A1307 Cambridge South East Transport

Local Liaison Forum 26th January 2020
Phase 1 General Scheme Update
Greater Cambridge Partnership

Scheme 9 Hildersham Crossroads - You Said, we did

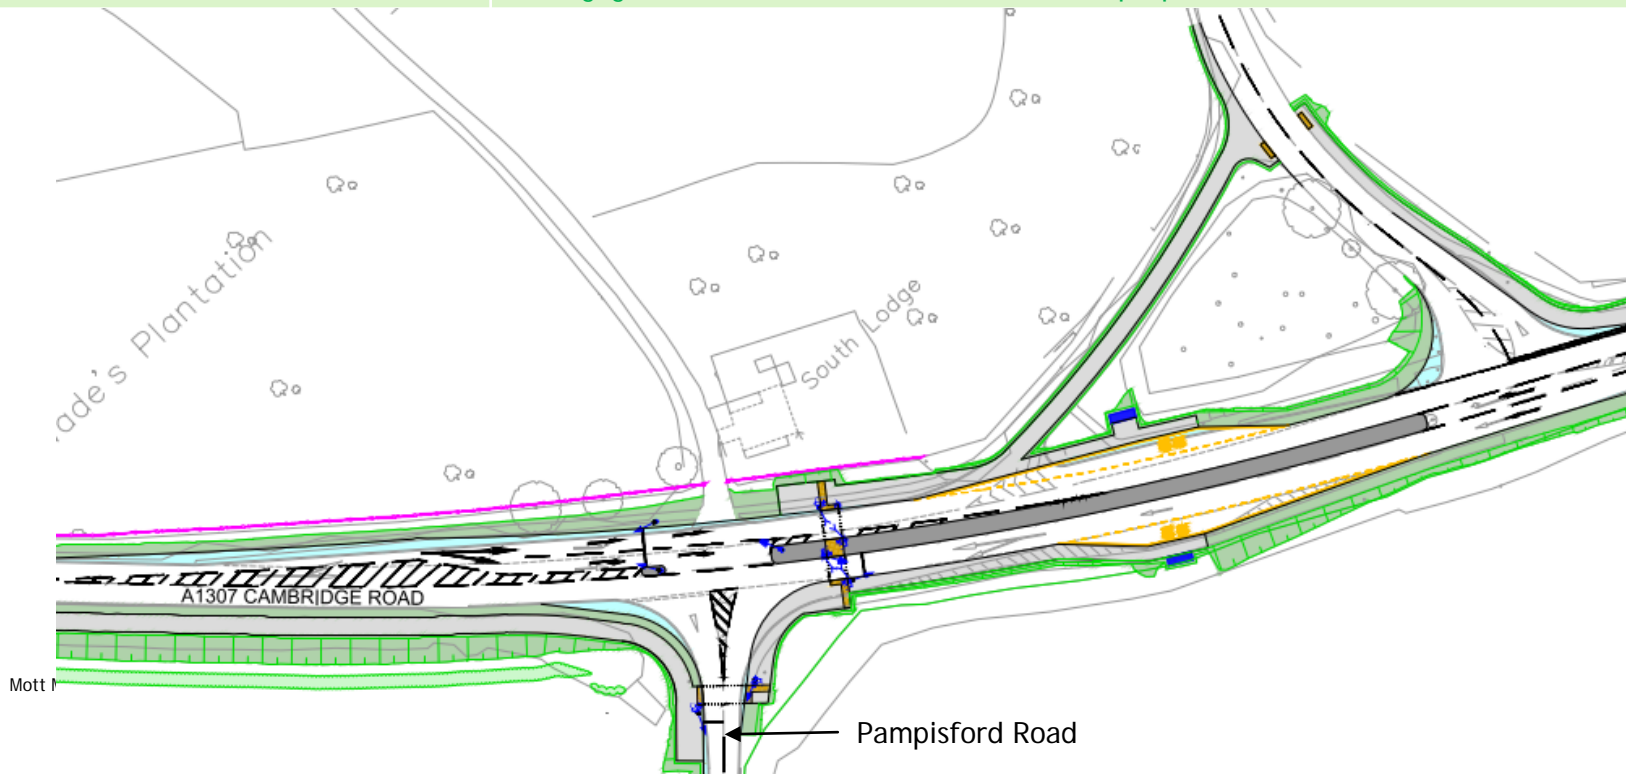
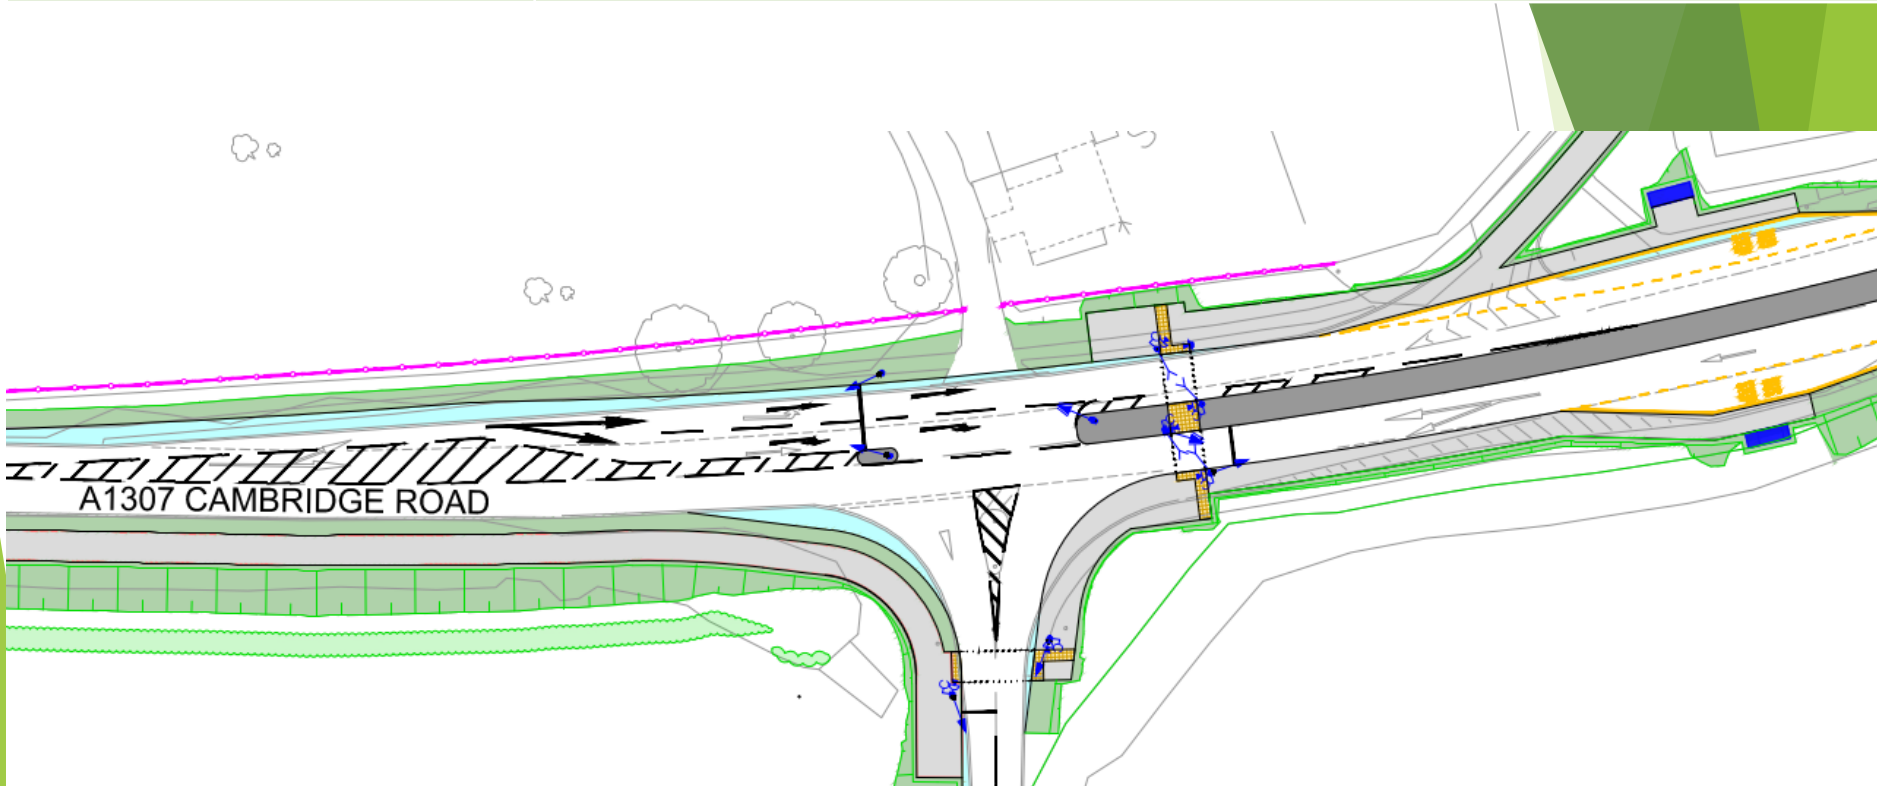
Comment	Action
Reconsider re-introduce traffic signal junction at this location	Re-evaluated traffic impact on A1307 vs benefits to active Travel Users and follow up discussions with CCC Signals and Safety teams Re-engaged with Landowners with alternative proposals

Scheme	Status
9 - Hildersham Signalised Junction	Signalised Junction remains preferred scheme following feedback from previous LLF and proposals made to secure formal agreement for the land necessary to construct the scheme

Scheme 3 Section 5 – You Said, we did

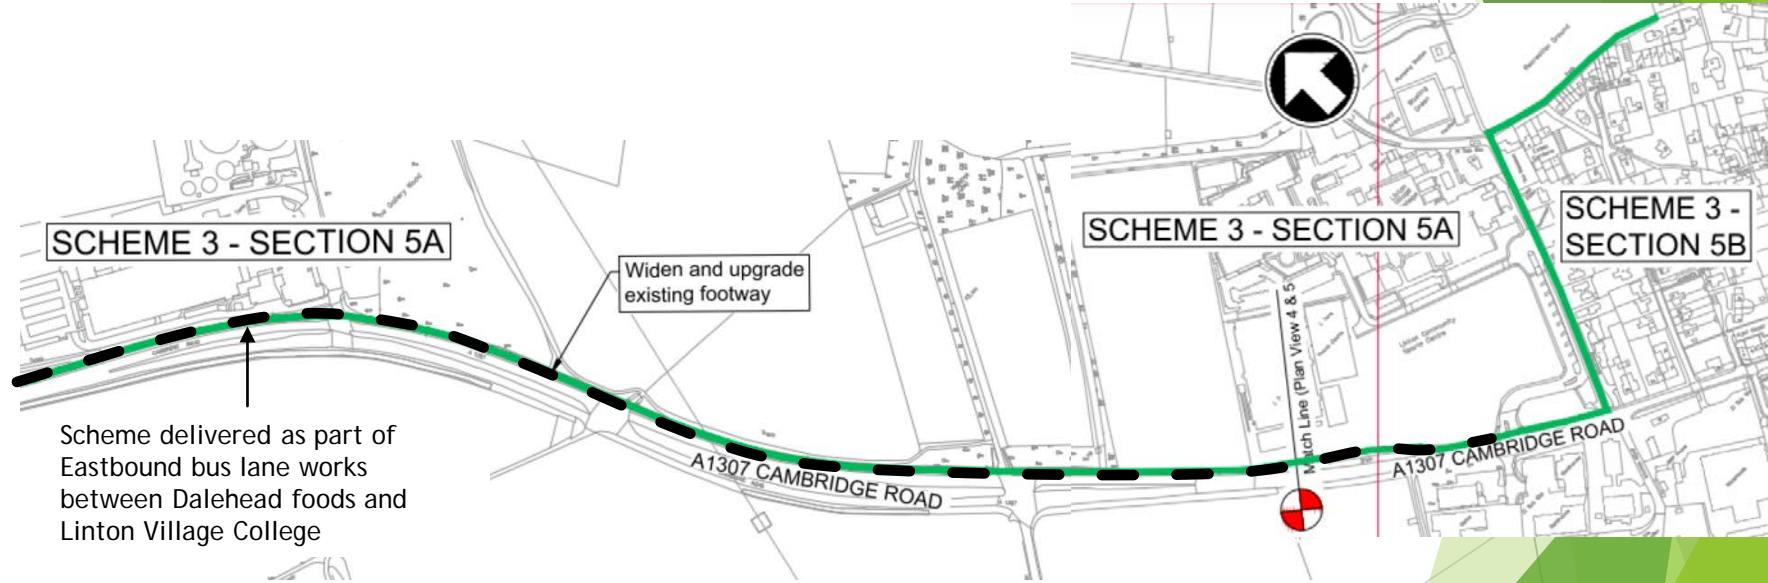
Comment	Action
Improve configuration of crossing at Linton Village college	Subject to completion of funding review, looking to make minor civils adjustments to improve space on island and reduce radii to reduce crossing distances.
Consider segregation of cycles and pedestrians on Linton Meadows	<p>Not taking forward as Linton Greenway is a shared path throughout its length and existing path width of 3m does not lend itself to widening further to achieve segregated approach.</p> <p>Resurfacing of existing path is currently within scope</p>

15 - Bartlow Road Roundabout - detailed layout of proposed roundabout

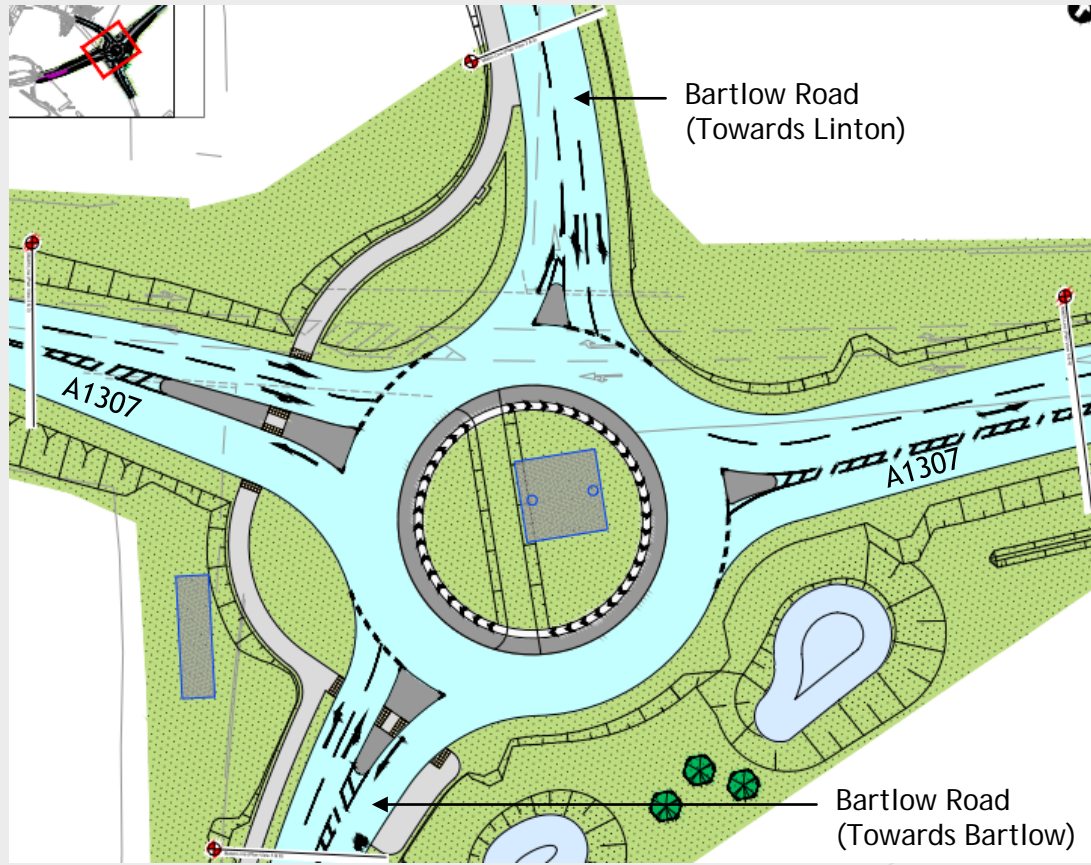
You Said	We Did
Review entry and exit crossing distances on southern arm of roundabout	<p>Review complete:</p> <p>Exit Arm – Crossing width reduced through increased width of island, thereby providing improved space for active travel users.</p> <p>Entry Arm – Traffic modelling discussions with CCC Transport team required additional lane on approach in order to minimize tailbacks into Linton during peak hour.</p>
Rural Parishes Request to provide improved linkages between rural villages, notably Bartlow, Horseheath, West Wickham	<p>Initial reviews undertaken to identify potential options and high level costing work undertaken. However, in view of current pending funding reviews ongoing elsewhere on the scheme, additional schemes are not being progressed further at this stage.</p>
